Submit 1 Copy To Appropriate District Office	State of New Mexico			Form C-103
District I - (575) 393-6161	Energy, Minerals and Natural Re	esources	WELL ADDATO	Revised July 18, 2013
1625 N. French Dr., Hobbs, NM 88240 District II - (575) 748-1283			WELL API NO. 30-025-06050	
811 S. First St., Artesia, NM 88210	OIL CONSERVATION DIV		5. Indicate Type of	Lease
<u>District III</u> – (505) 334-6178 1000 Rio Brazos Rd., Aztec, NM 87410	1220 South St. Francis I	Dr.	STATE	FEE X
District IV - (505) 476-3460	Santa Fe, NM 87505		6. State Oil & Gas	
1220 S. St. Francis Dr., Santa Fe, NM 87505			859210	
SUNDRY NOTICES AND REPORTS ON WELLS			7. Lease Name or U	Jnit Agreement Name
(DO NOT USE THIS FORM FOR PROPOSALS TO DRILL OR TO DEEPEN OR PLUG BACK TO A DIFFERENT RESERVOIR. USE "APPLICATION FOR PERMIT" (FORM C-101) FOR SUCH			Van Etten, L.	-
PROPOSALS.) 1. Type of Well: Oil Well . Gas Well . Other			8. Well Number	10

Schematic - Vertical - Proposed Well Name: VAN ETTEN 10E

Van Etten #10 Plug and Abandon Wellbore

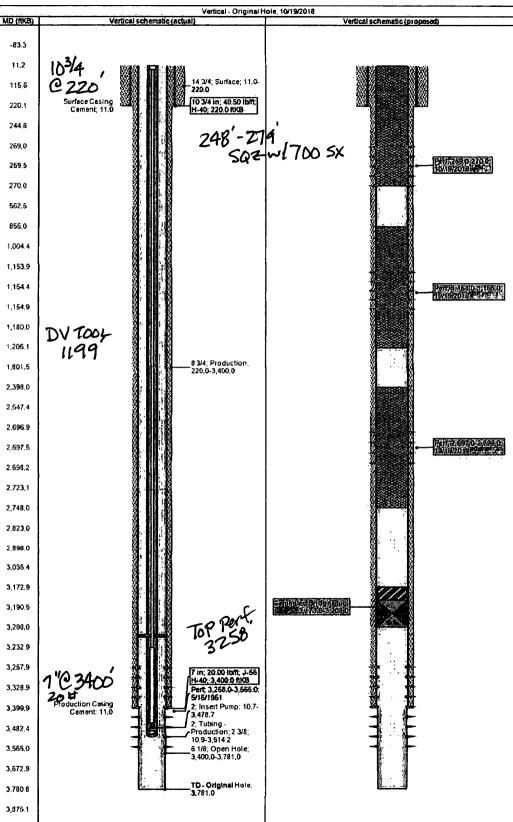
- 1. MIRU WSU.
- 2. POH with Rods and pump.
- 3. ND WH and NU BOP.
- 4. POH with tbg and BHA. LD BHA.
- 5. MIRU WL.
- 6. Rlh and set a CIBP @ 3208'.
- 7. Dump bail 35" of cernent on CIBP'. Cale'd TOC @ 3173'. --- SPOT 25 SX CMT ON CIBP 8. POH RD WL. WOC. CIRCULATE MUD LADEN FLUID, PRESSURE TEST
- 9. RIH with WLW and tag TOC. Note cement top in wellview.
- 10. POH with WL. Perf the 7" production casing at 2698'.

VERIFY CMT TO SURFACE ALL STRINGS
